# Revised Work Plan to Evaluate Effective Groundwater Capture at Tronox Extraction Systems, Tronox LLC, Henderson, Nevada

ENSR Corporation  
August 2007  
Document No.: 4020-023-160

### **Response to NDEP (June 26) Comments to the May 30, 2007 Draft Work Plan**

**Tronox Response to NDEP June 26, 2007 Comments  
on the Draft Groundwater Capture Work Plan dated May 30, 2007**

**PROPOSED WELLS AT  
THE INTERCEPTOR WELL FIELD**  
Capture Zone Workplan  
Tronox Facility  
Henderson, Nevada

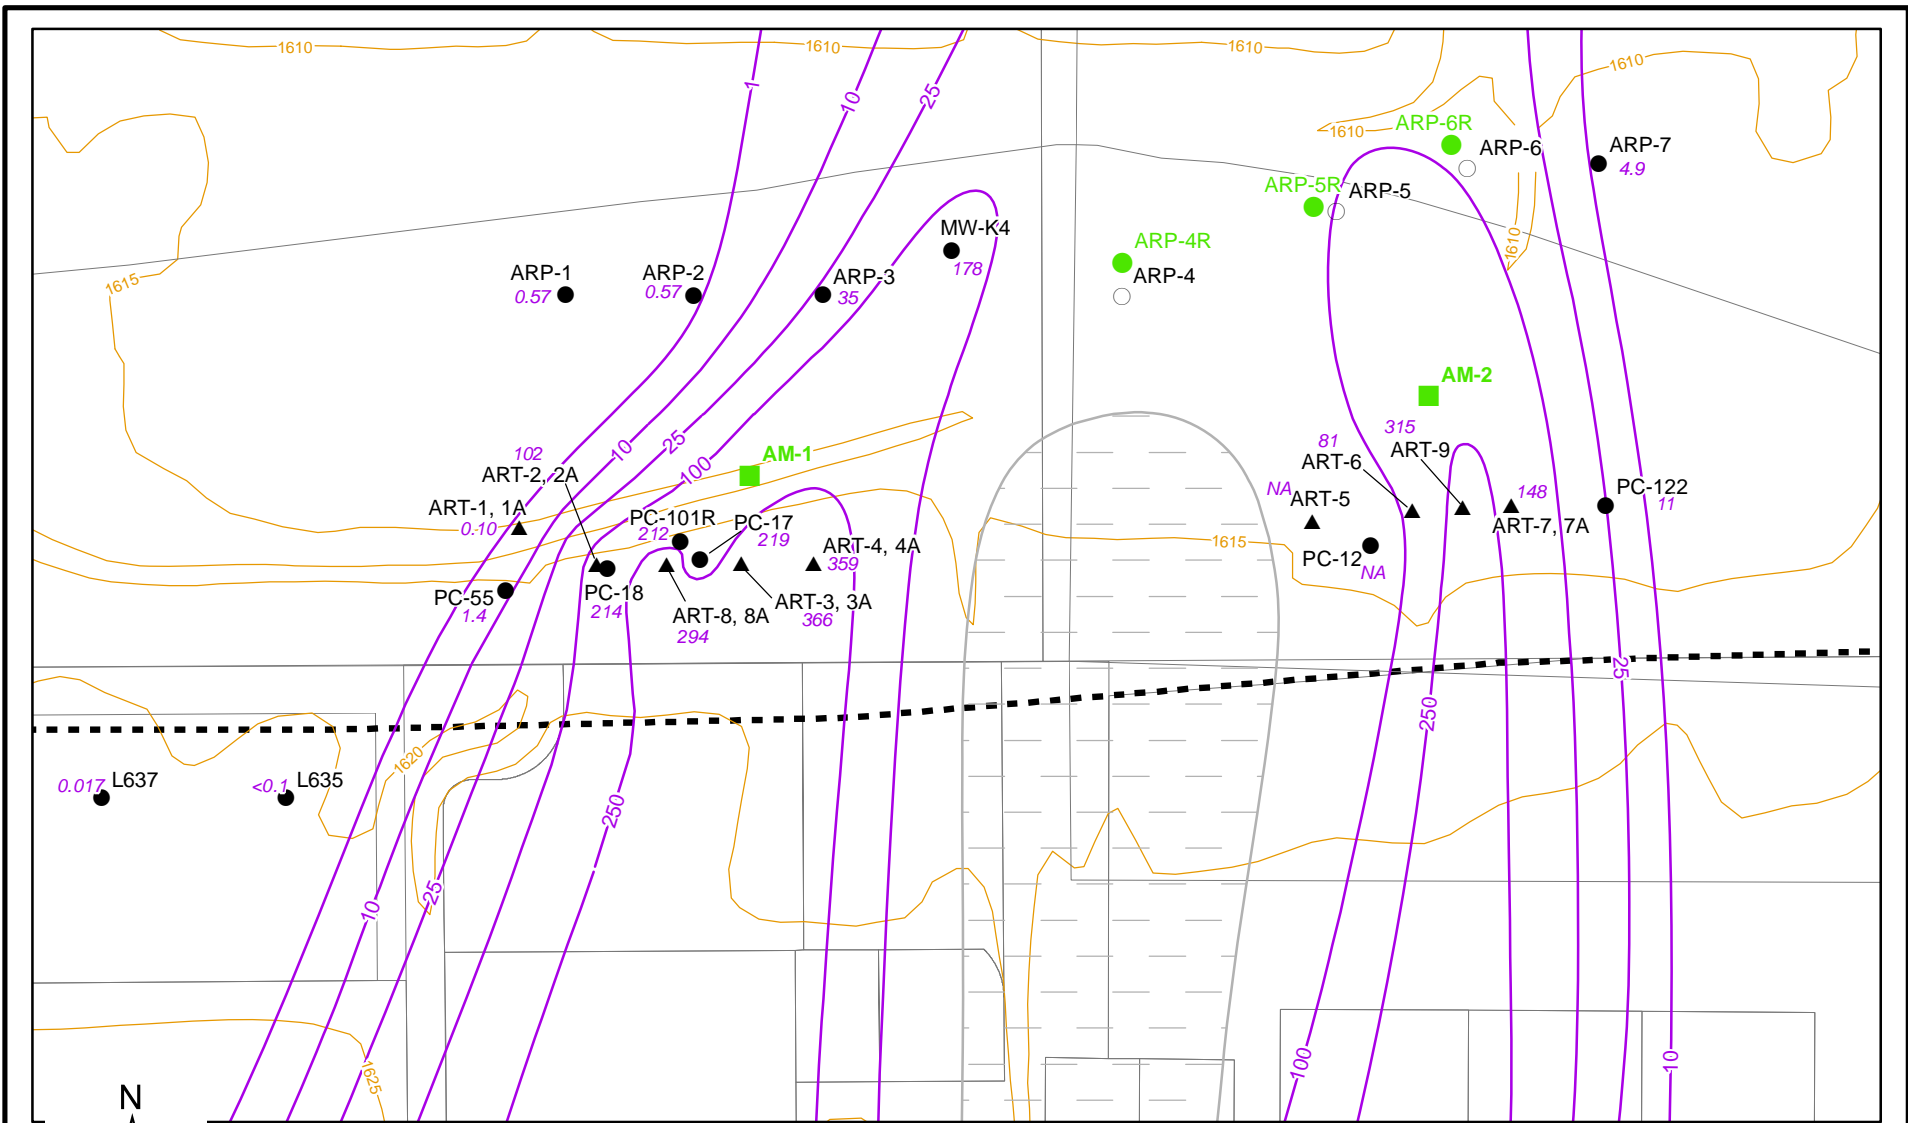
- a. The NDEP requests that this statement be supported with the installation of at least two monitoring wells at both locations as illustrated in Figure 1 (see following comment) to measure gradient. Flow may then be calculated using these newly installed monitoring wells and M69 (west side) and M74 (east side).

- b. Please note that the NDEP is including Figure 1 as example of possible well locations for comment clarity. TRX may propose different well locations.

- c. TRX should include a map illustrating the proposed locations of the monitoring wells. This comment applies to other portions of the work plan as well.

Section II, page 4 of 7, Proposed Additional Evaluation, 3<sup>rd</sup> bullet, the NDEP requests three shallow (water table) monitoring wells at each end of the barrier wall to evaluate effectiveness of the barrier. (See also comment above.)

a. /b. /c. TRX will install groundwater monitor wells at each end of the barrier wall at locations shown in Figure 2 of the Revised Work Plan to Evaluate Effective Capture at Tronox Extraction Systems (August 2007). TRX will provide a map showing the proposed well locations along with any other proposed monitor wells,, piezometers, or additional recovery wells in the revised work plan.

*TRX has proposed the installation of groundwater monitor wells and/or piezometers on the east end of the barrier wall (see RTC 10 a/b/c), and plans to install at least one new recovery well with attendant monitor wells or piezometers on the west end. This request for three shallow monitor wells at each end of the barrier wall will be reviewed in conjunction with the planned well installation proposals.*

**PROPOSED WELLS AT  
THE ATHENS ROAD WELL FIELD**  
Capture Zone Workplan  
Tronox Facility  
Henderson, Nevada

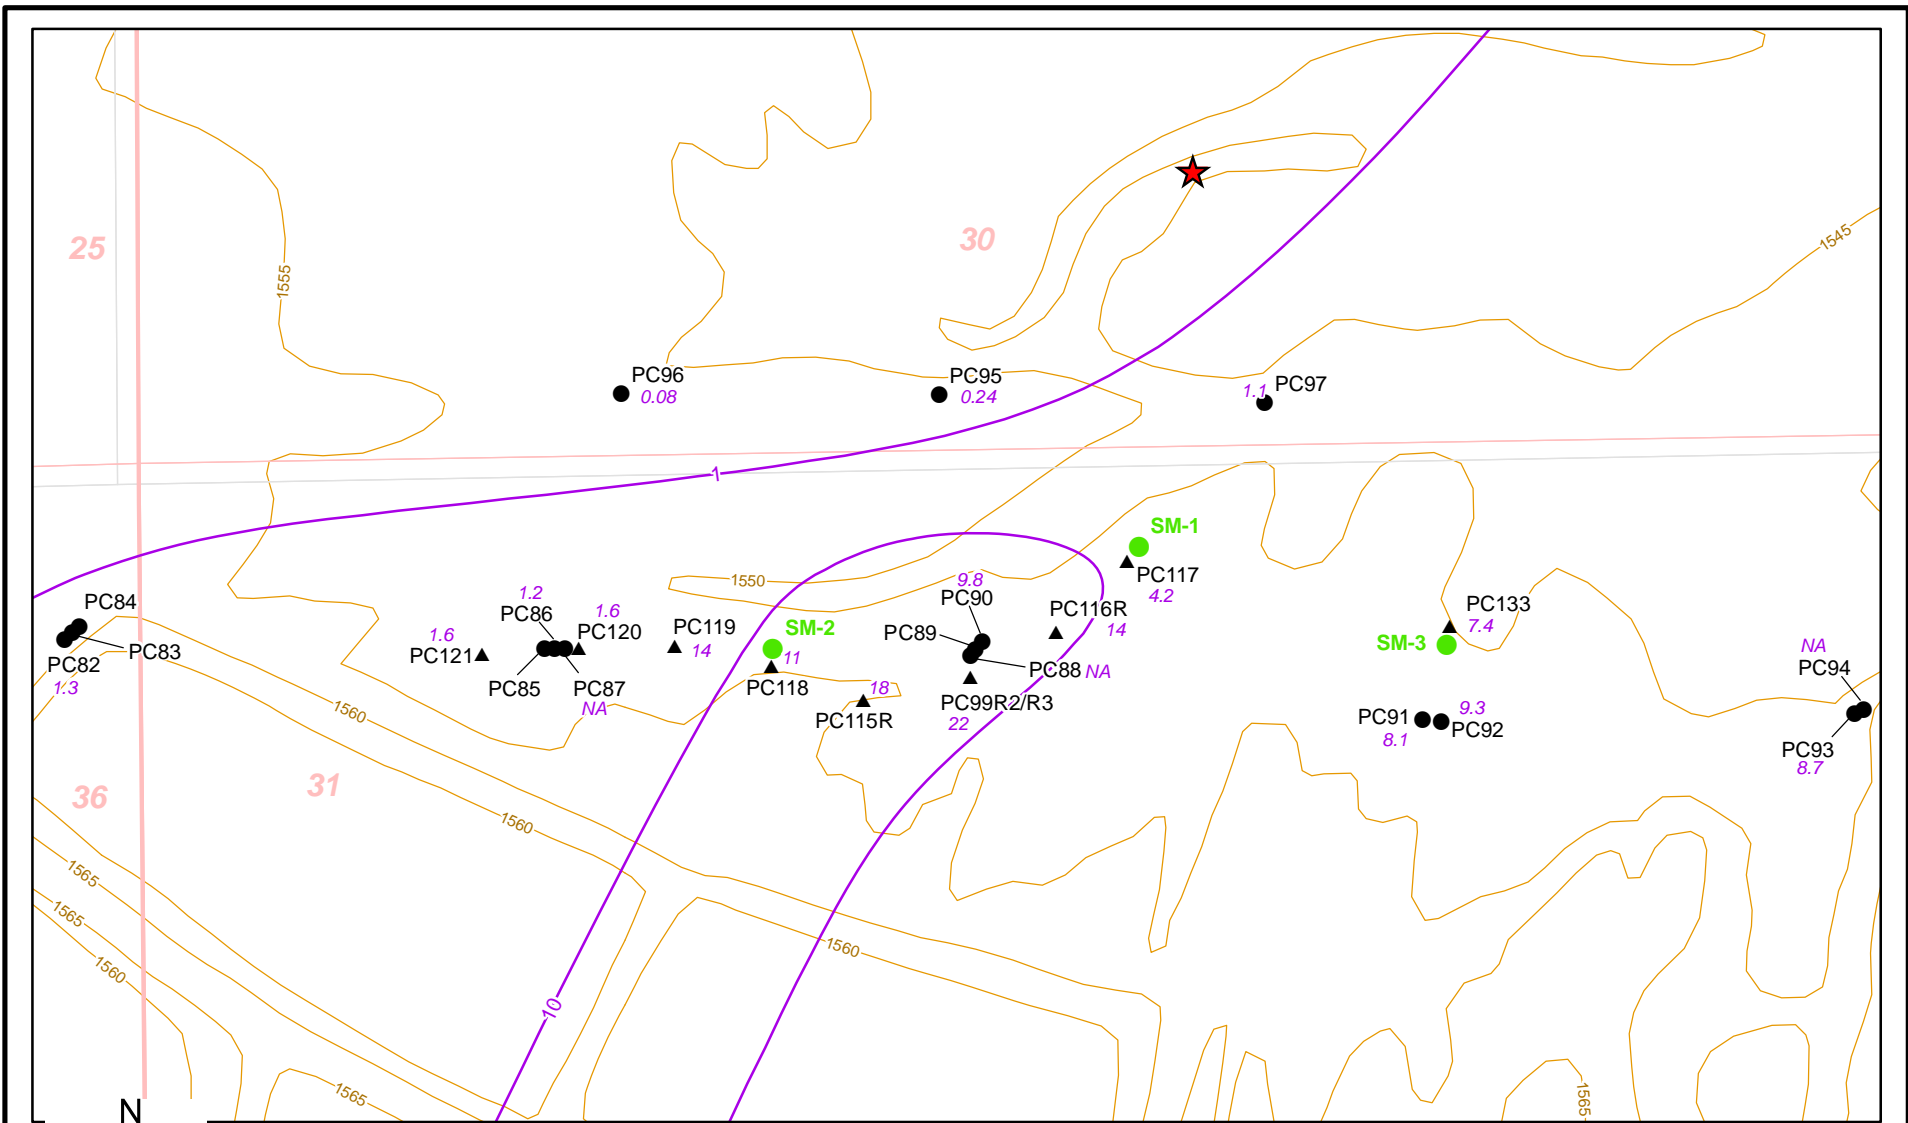
Section II, page 5 of 7, Athens Road Extraction Gallery, Inward Flow, the NDEP does not agree that inward flow is demonstrated by the Potentiometric Surface Map, Fourth Quarter 2006. West of the Tertiary Muddy Creek Formation (TMCf) high the groundwater elevation contours and data as posted on the map show a gradient south to north, *i.e.*, towards the wash. East of the TMCf high there is insufficient data to support the closed (depression) contour as drawn on the map. No groundwater elevation data have been reported between the closed 1590 contour and the 1590 contour to the north to indicate a higher water level. An alternative way to map this data could include connecting the 1590 depression contour with the same 1590 contour to the north.

**Proposal:** In order to demonstrate upward vertical head and inward flow, two additional nested piezometers, AM-1 and AM-2 will be completed 100 feet down-gradient of recovery wells ART-3 and ART-9 in the western and eastern sub-channels, respectively. Proposed well locations are shown on **Figure 3**. The new wells will allow calculation of flow vectors and vertical head to confirm capture.

Additionally, the three recently abandoned ARP-series piezometers, ARP-4R, ARP-5R and ARP-6R downgradient of the well field will be re-established nearby their former locations (**Figure 3**). Proposed well completion data are provided on **Table 1**.

*Groundwater elevation data to be presented in the July 2006 – June 2007 Annual Performance Report show that a closed contour (depression) is mapped encircling Athens Road WF drawdown on both sides of the Muddy Creek Formation high. To test the validity of this interpretation of the potentiometric data TRX will install additional nested piezometer wells downgradient of the ART wells to demonstrate inward flow.*
